TITLE CONNECTOR HARNESS STRAIN RELIEF				PIB NO. DK 3045	
PRODUCT LINE:	TAPE DISK FORMATTER	<input type="checkbox"/> <input checked="" type="checkbox"/> <input type="checkbox"/>	EQUIPMENT CHANGED D3000	MODEL SERIES AFFECTED D3000	EFFECTIVE DATE July 1, 1975

TITLE CONNECTOR HARNESS STRAIN RELIEF

PIB NO.
DK3045

FIG. 1

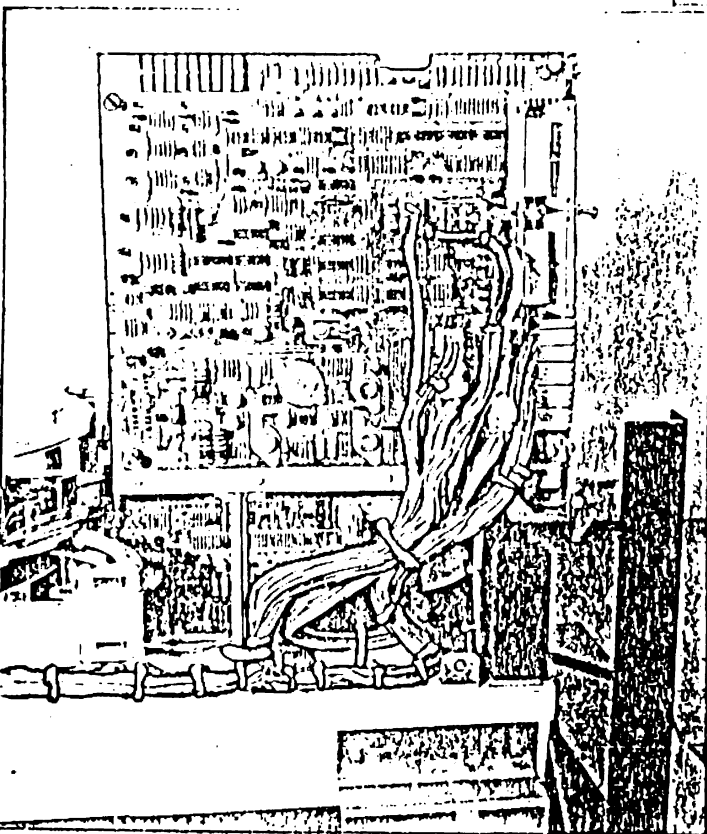
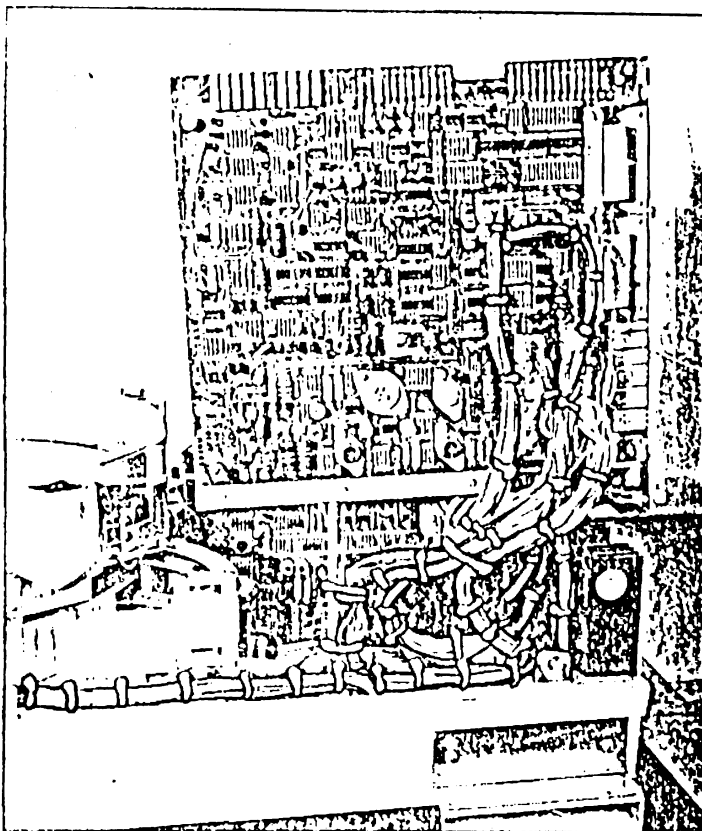
Folding down the Logic and Servo PCBA's can, in some circumstances, cause the Molex connectors, to ease off their mating pins. Repeated opening and closing of the PCBA's can result in intermittent contact being made to these pins.

This effect can be overcome by the simple operation of removing some of the tie wraps, and making the connector harness less rigid.

Figs. 1 and 2 show views of the harness before and after removing tie wraps.

Showing unit before tie wraps are removed.
Top Load unit pictured,
but improvement applicable
to Front Load units also.

Unit shown with minimum number
of tie wraps necessary to
keep connector harness tidy.

Note: 15 tie wraps have been
removed.
